# ENVIRONMENTAL REVIEW TEAM REPORT

COLONIAL HILL ESTATES  
NEWTOWN, CONNECTICUT

MARCH 1979

FIGURE 3.  
**BEDROCK OUTCROP MAP**  
BASED ON FIELD OBSERVATIONS ONLY

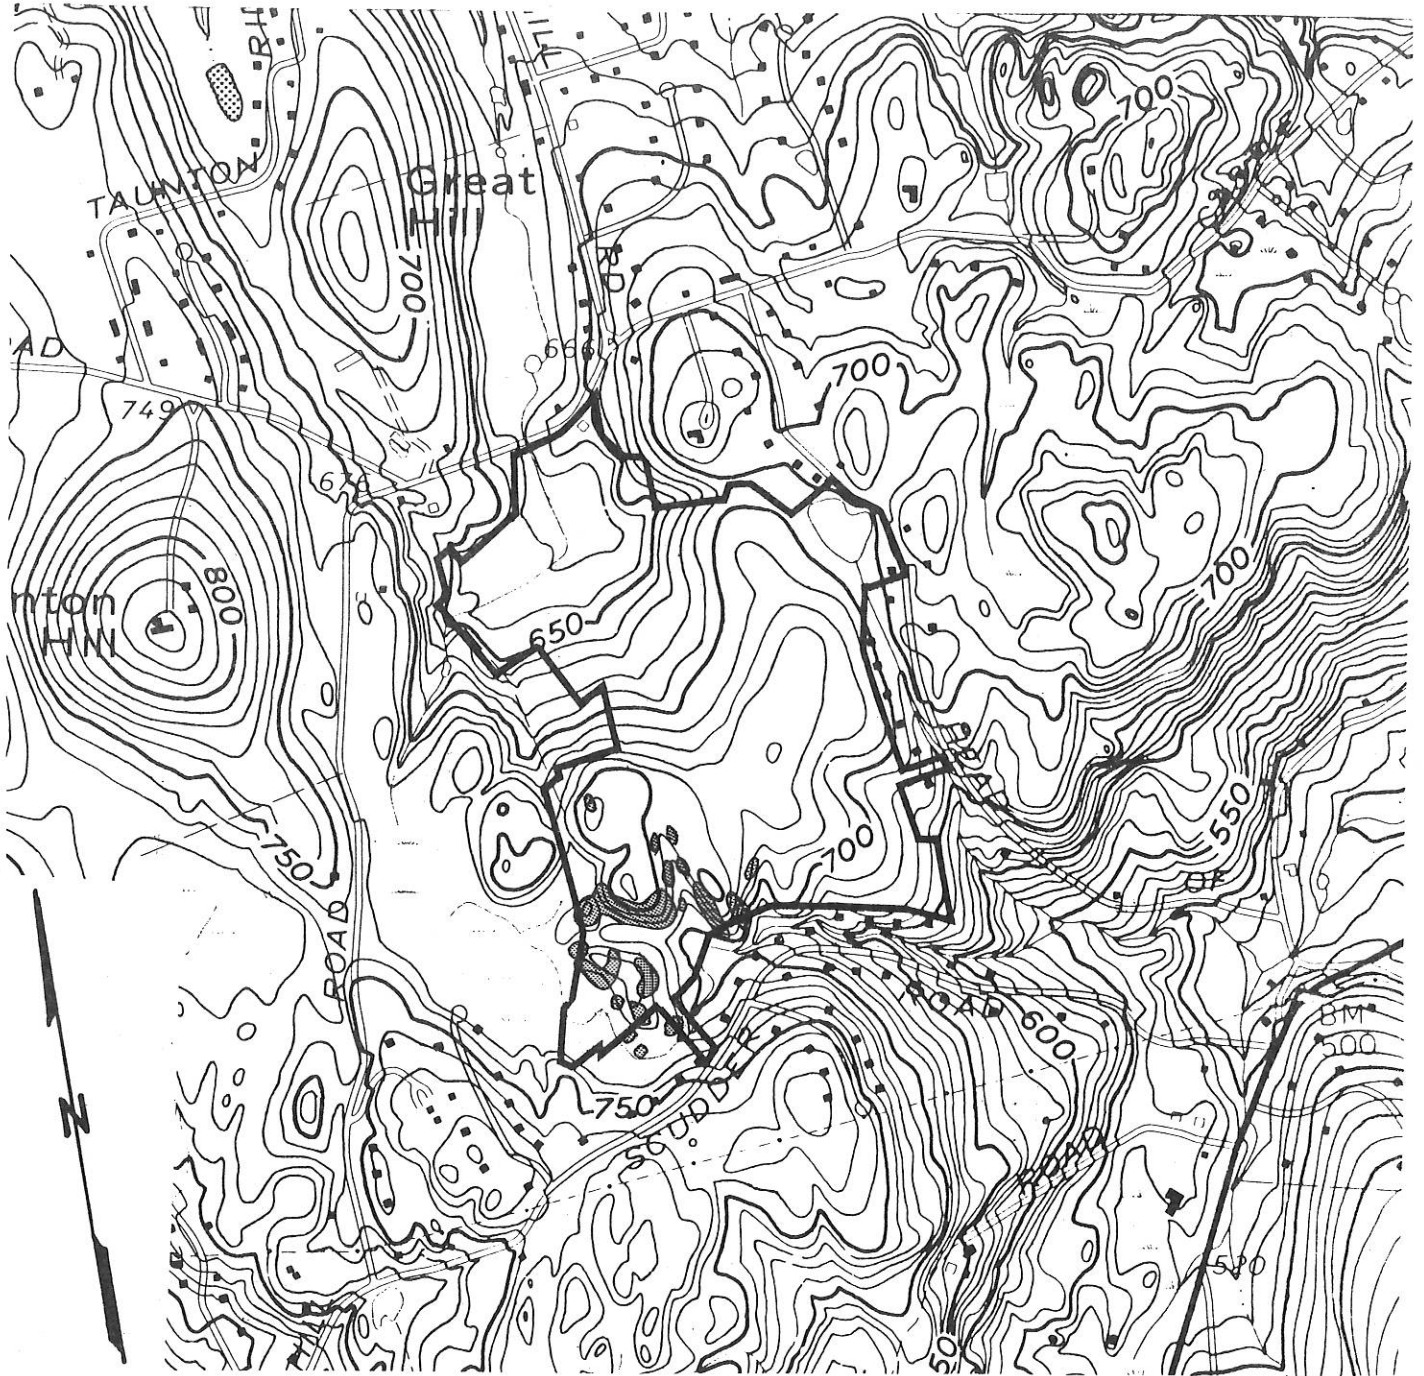
later redeposited directly from the ice. The topmost part of the till is often sandy and relatively loose, but lower layers are typically siltier and very compact. Soils data suggests that the most compact till is commonly near the surface in the southern and eastern sections of the site, while the sandier variety is more common in the moderately sloping northwest section. The till appears to be generally thicker than 10 feet in the northern half of the site, but it is commonly thinner or absent in the southern half. The bedrock outcrop map which accompanies this report (Figure 3) gives a general indication of where the till is thinnest.

FIGURE 4.

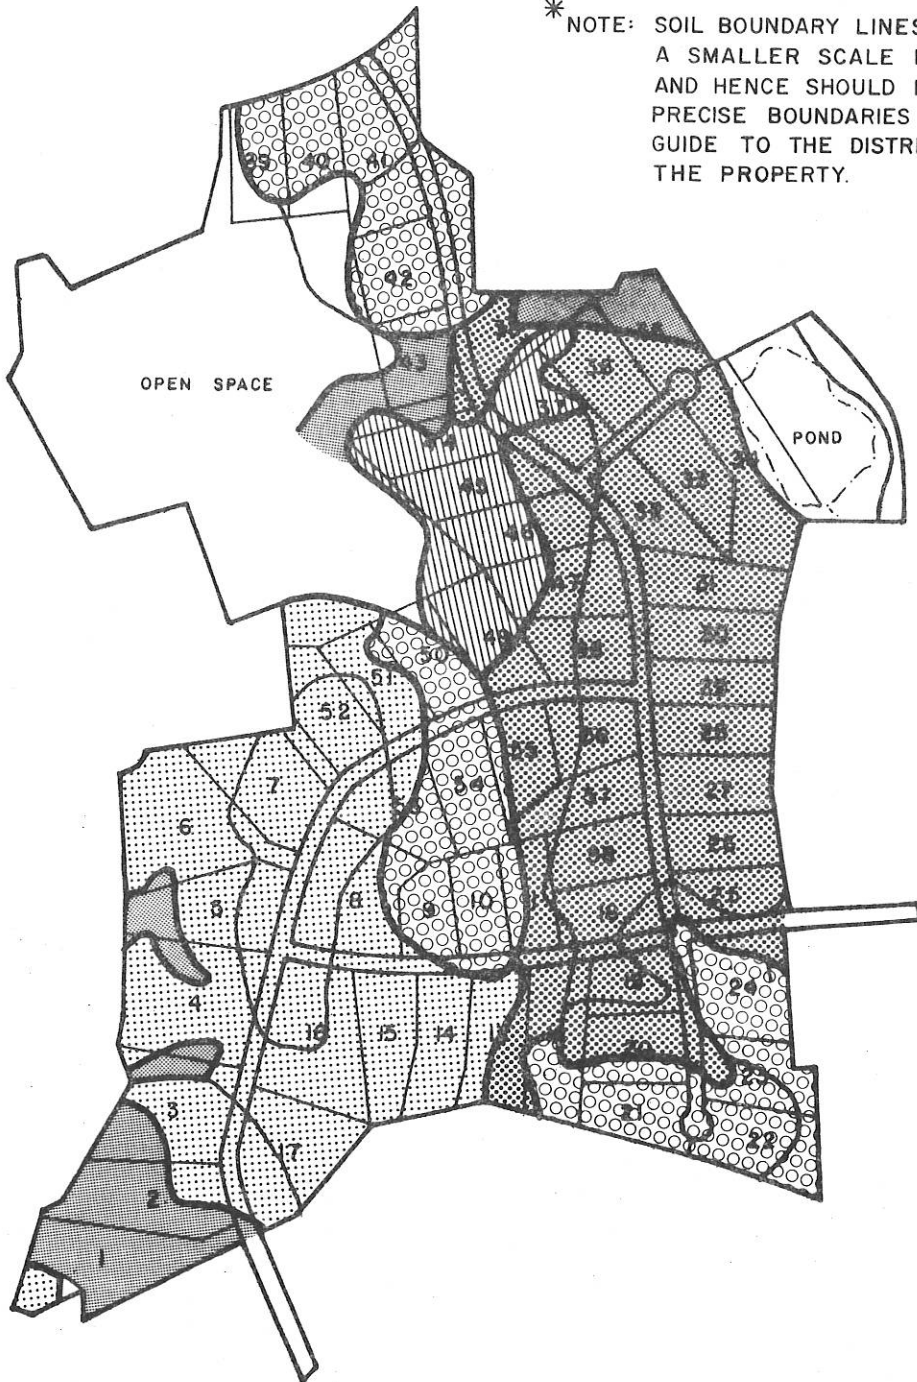
In terms of proposed lots, twelve consist primarily of group two soils, twenty-nine of group three soils, fourteen of group four soils and three of group five soils (see Figure 4).

These are permanently wet soils that are unsuited for residential development. (It should be noted that more detailed inland wetlands mapping by the applicant indicates lot #2 is not predominantly wetland.)

FIGURE 5.  
**VEGETATION TYPE MAP**

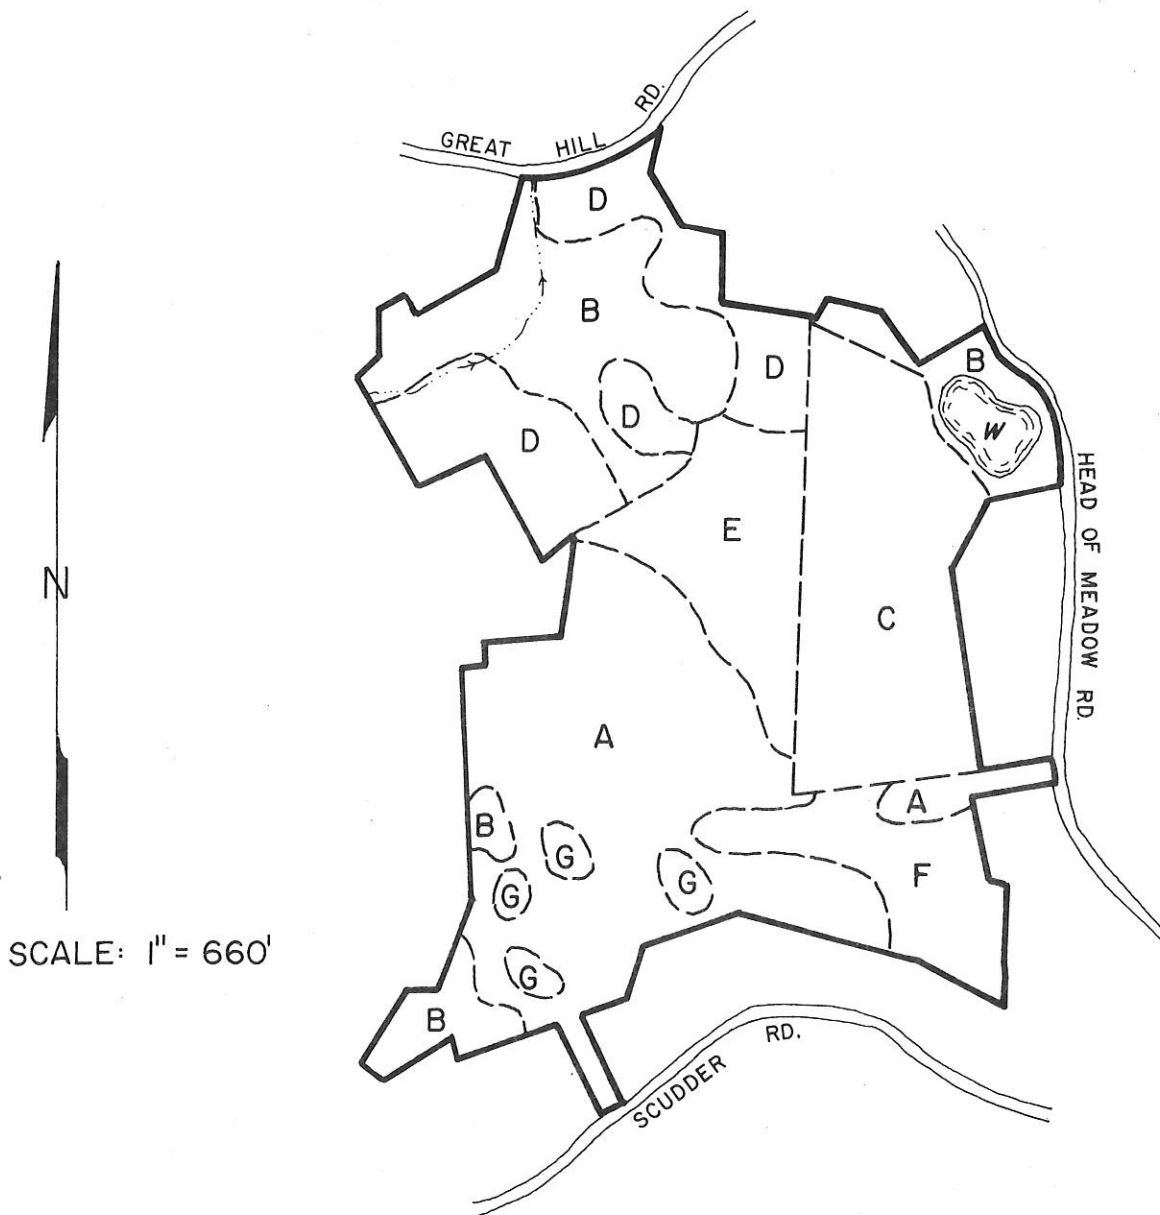
The soils associated with the hardwood swamp (Stand B) are characterized by a permanent high water table. These saturated and poorly aerated soils limit the depth of tree and shrub root systems. Growth rates of the trees present are slow and tree quality is generally poor. Management of these areas for timber production is usually not economically feasible because of the severe limitation the high water table imposes on equipment use.

The hardwood swamp and wetland areas making up Stand B contain very fragile plant communities. Permanent changes in the water table may kill the trees, shrubs and herbaceous vegetation growing in these areas. Hence, efforts should be made to alter the wetland ground water levels as little as possible.

Another concern in the Stand B areas is that the saturated soils and shallow root systems cause the larger, more crowded trees to be highly susceptible to windthrow. Openings and channels which allow wind to flow through rather than over the trees in this stand should be avoided.

Thinnings in both stands A and E would stimulate the growth rates of residual trees by reducing crowding. Thinnings would also improve aesthetics and stand quality by removing unattractive, unhealthy and poor quality trees. Removal of about one-third of the volume in these stands would be beneficial and should be considered by the developer. Although there may not be enough volume in unhealthy, poor quality, sawlog-size trees to interest a commercial harvester, commercial removal of fuelwood may prove a feasible alternative. Such fuelwood thinnings should leave untouched the more aesthetic, healthier, higher quality trees.

Planting a hedgerow on the eastern portion of the open field (Stand C) with a combination of white pine, hemlock and larch, eight to ten feet apart would improve the aesthetics, wildlife habitat and variety of the area. This planting would also eventually act as a windbreak and provide a visual barrier between existing and proposed houses.

FIGURE 6.  
HYDROLOGIC DESIGN POINTS & THEIR ASSOCIATED  
WATERSHED AREAS\*

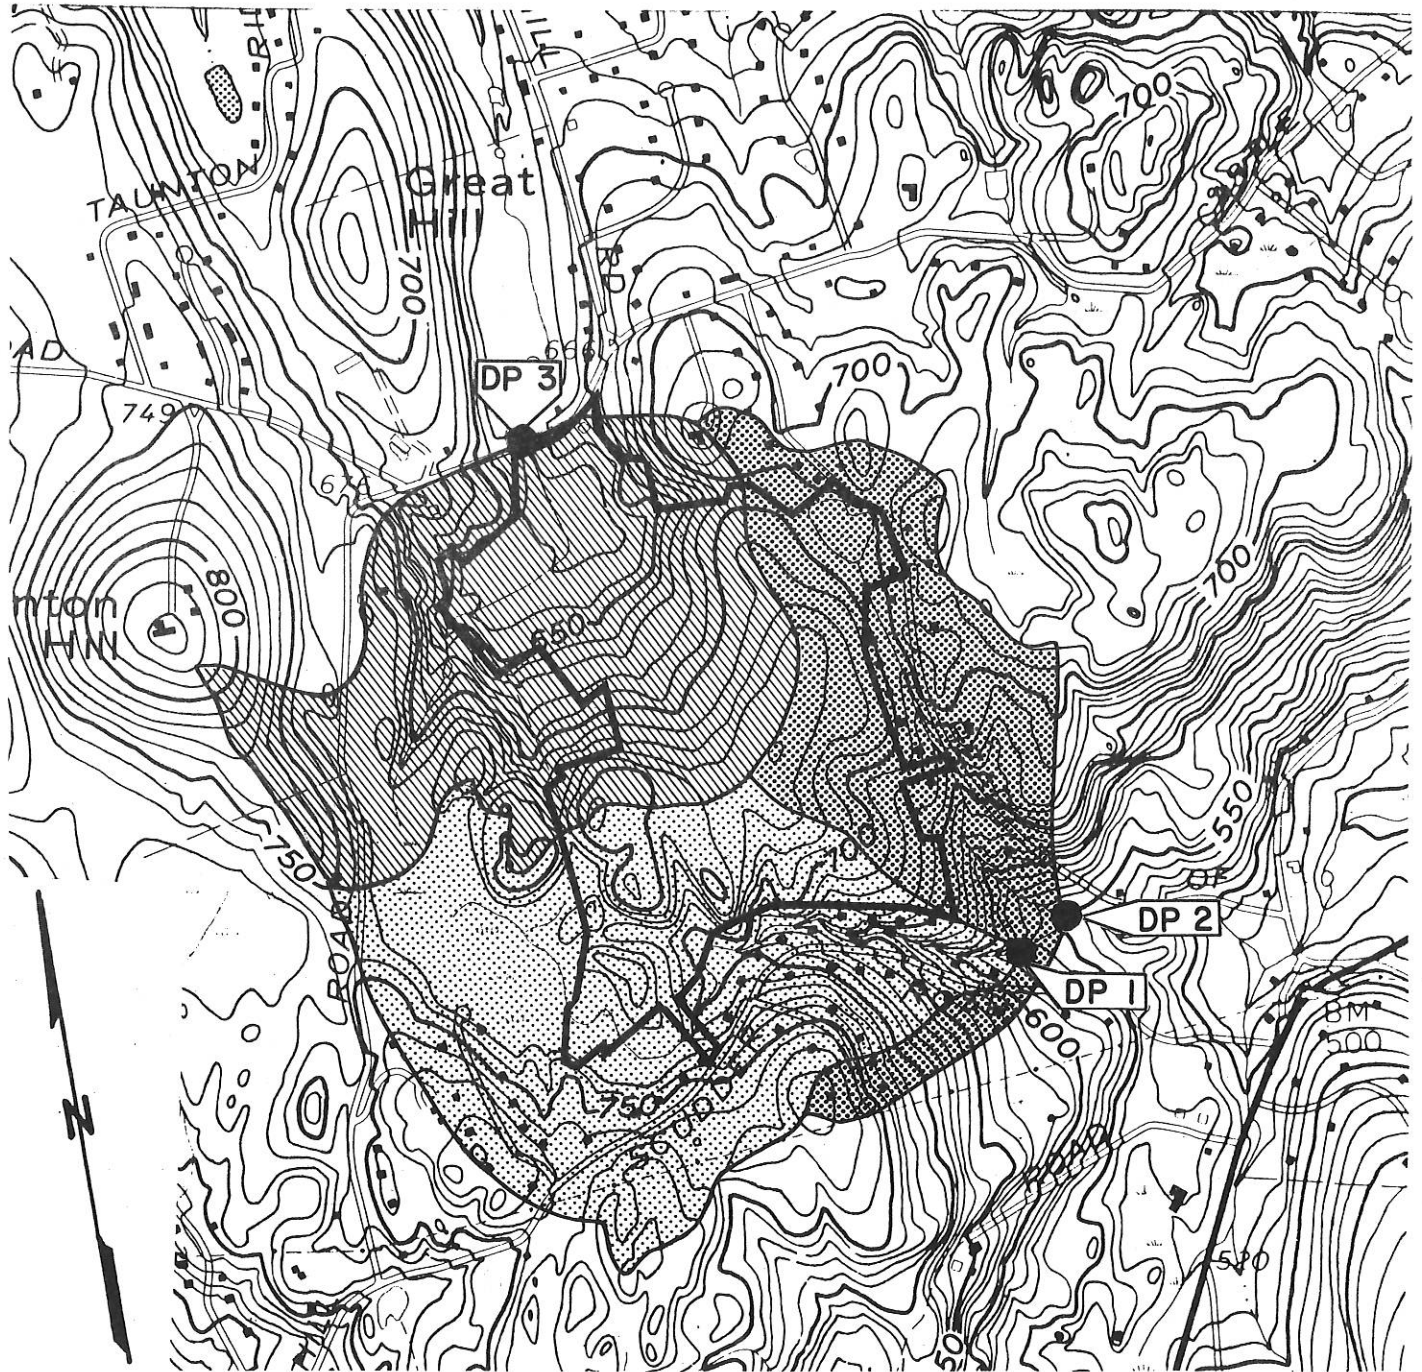
Three hydrologic design points are shown in Figure 6, as are their associated watersheds. Table 1 shows estimated present and anticipated future peak flows at those points for the theoretical 25-year, 24-hour storm and the 50-year, 24-hour storm.\* (Although no individual design point along the brook near Head of Meadow Road was studied, it is clear that the peak flow increases in that brook would be similar to those experienced by the brook along Scudder Road.)

The method used to calculate the peak flows was based on procedures outlined in Technical Release No. 55 of the Soil Conservation Service. Rainfall data from the U.S. Geological Survey Water Resources Division was also used. As indicated in Table 1, the peak flow increases would be generally less than 20 percent. While these increases should not generate significant additional flooding, as mentioned above, it may be useful to examine the sizes of any culverts along the brooks' courses to assure that these culverts are adequately sized to accommodate the increases. Most of the culverts along Scudder Road appear to have ample additional capacity.

The modest runoff increases may be more serious in terms of erosion; particularly in the steep, rocky southern section of the site. Conscientious erosion and sediment control plans and strict adherence to them are highly recommended for this fragile area.
